RE: TREE PROTECTION PLAN FOR 2040 ARROWSMITH DRIVE, OTTAWA

RESPONSES TO CITY COMMENTS

DRAWING: Tree Protection Plan

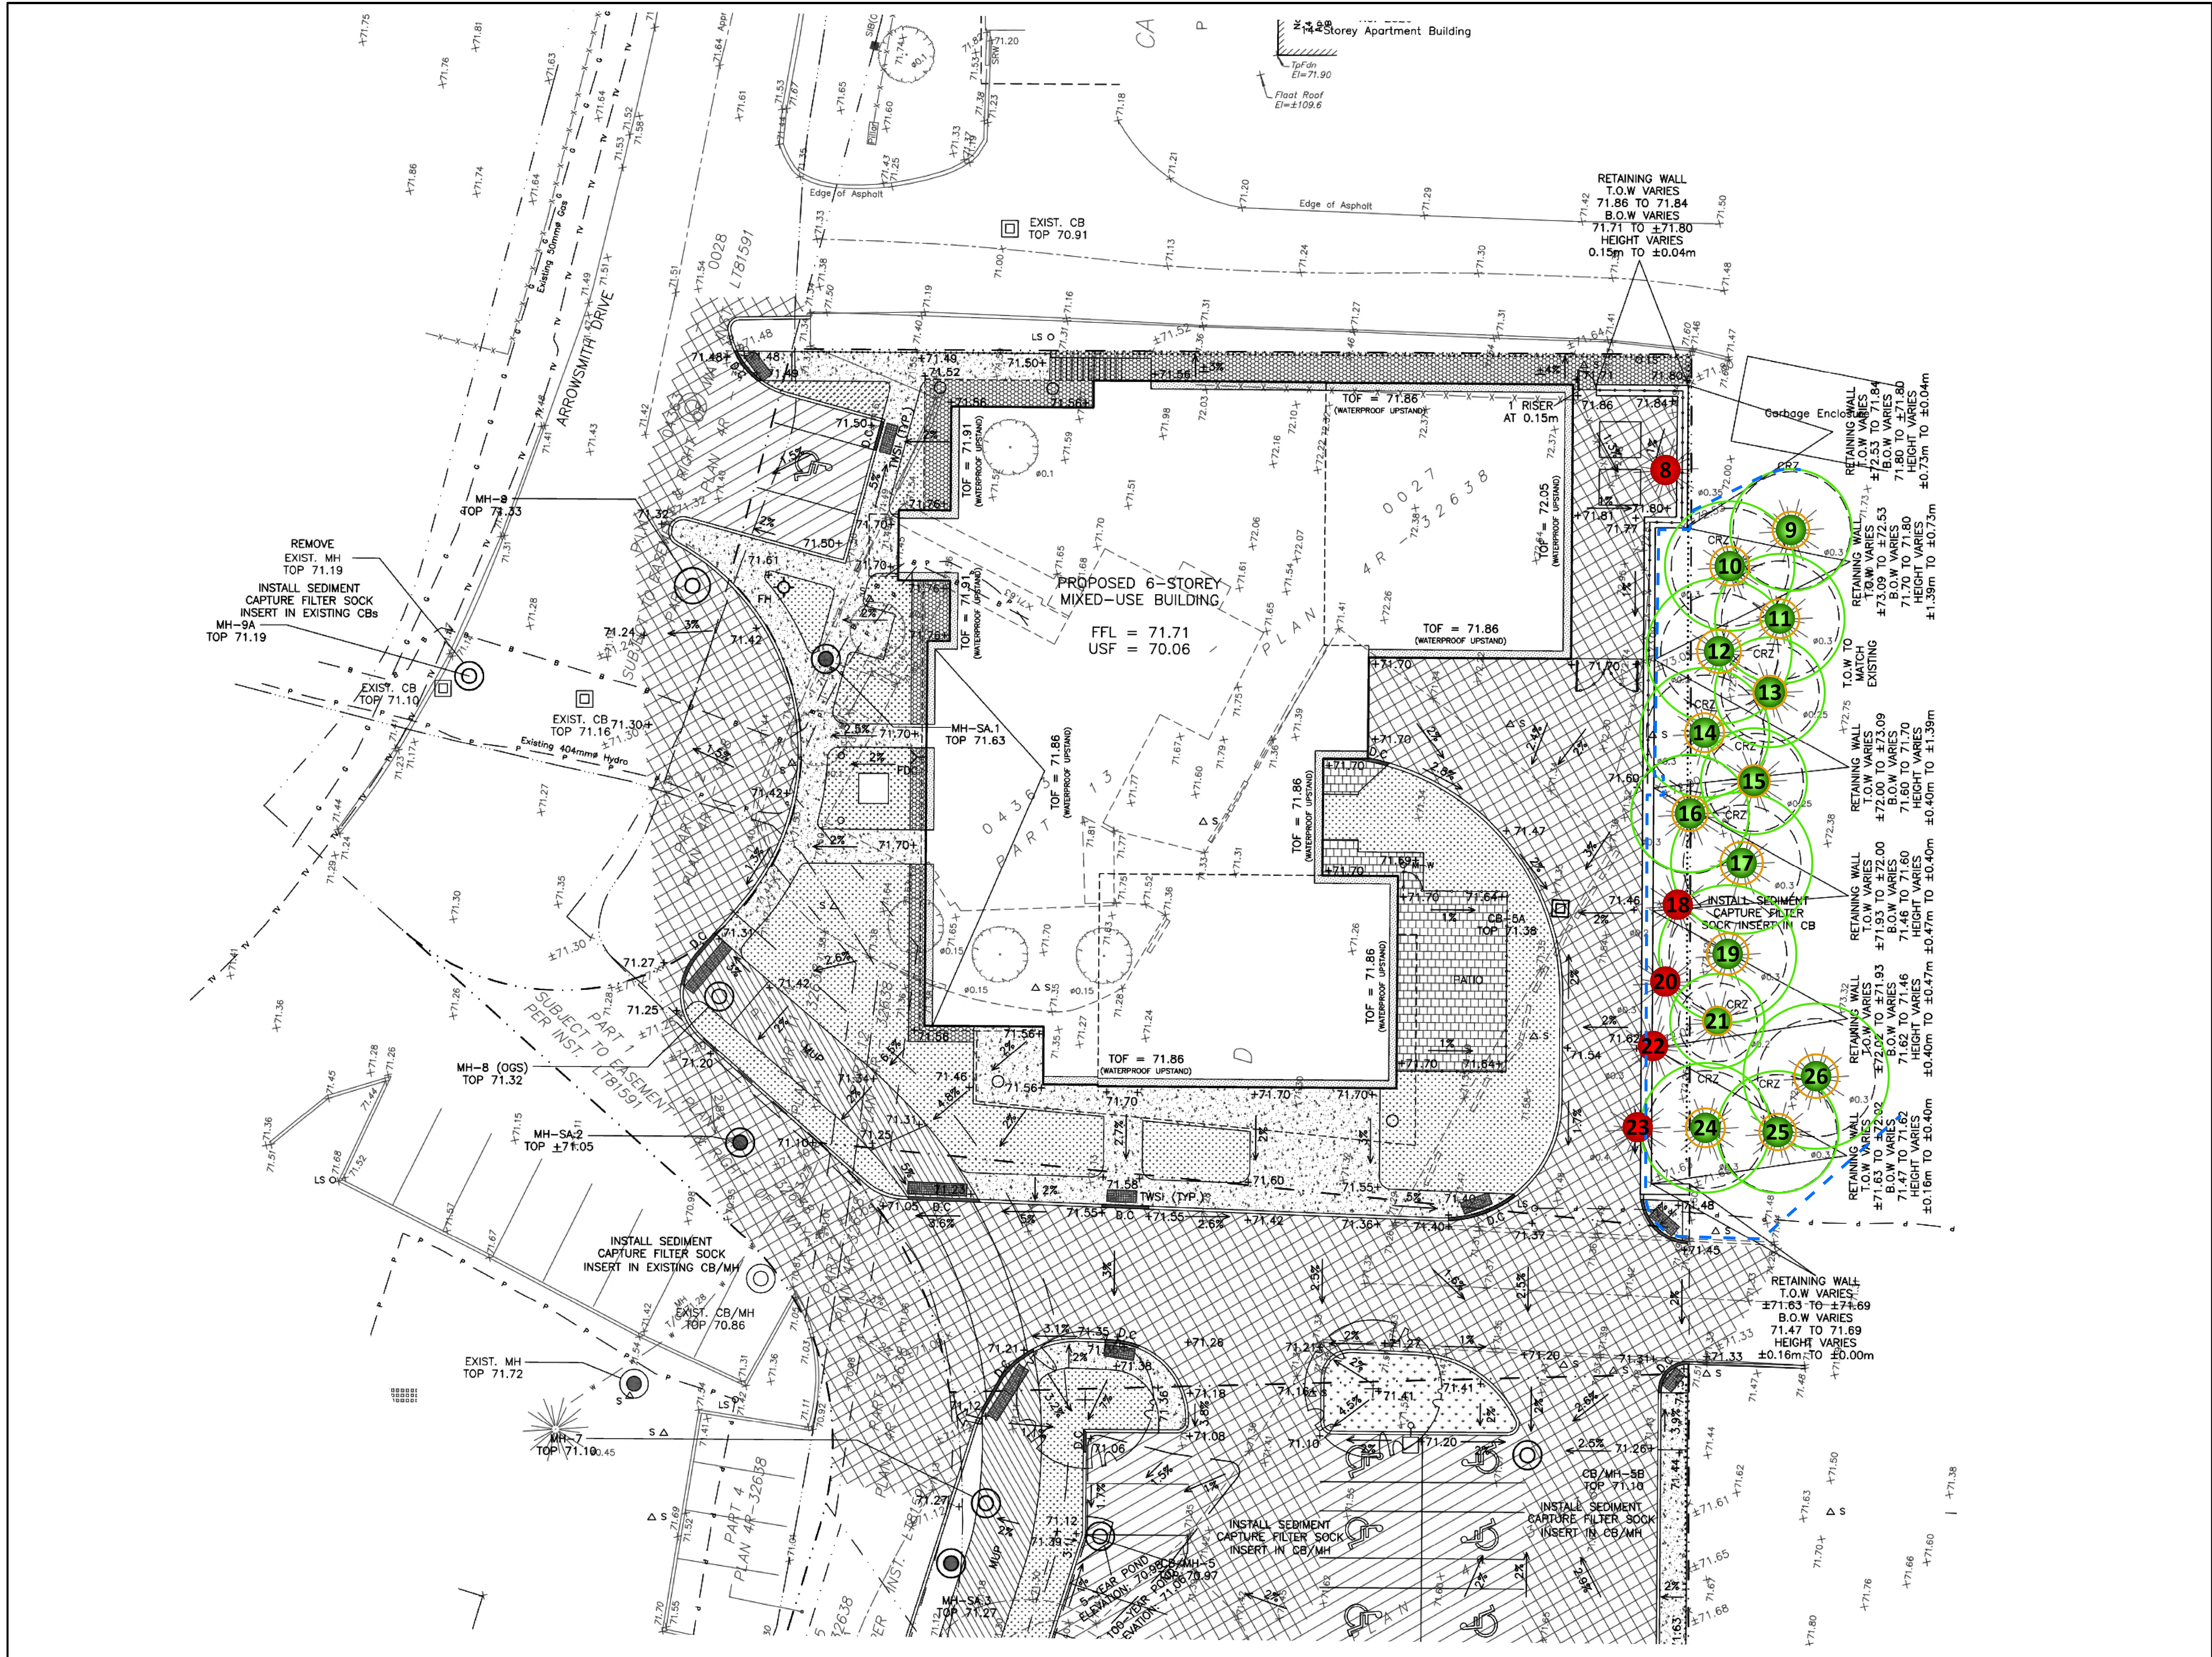
1b) *What extent of impact to the CRZs of these retained trees will occur and will it cause retained tree health to decline? Will there be excavation within the static root zone of the tree (Diameter x 3)?*

1g) *The consulting engineer and RPF must discuss the grade changes proposed along the eastern edge of the site. The trees are growing on a berm. A retaining wall, curb and access road will be installed along the edge of this growing space. Identify the implications of this work in the plan.*

At most, 30% of one tree’s CRZ (tree #16) will be impacted by grading. This equals the maximum recommended in ISA best management practices. As shown in the plan on page 7, no static root zones will be impacted.

The consulting engineer and forester have discussed the implications of the work proposed along the eastern edge of the site. Grading behind the proposed retaining wall remains as existing. Approximately 30% of the CRZ of tree #16 will be impacted while lesser amounts of the CRZs of trees #10, 12, 14 and 24 will be impacted.
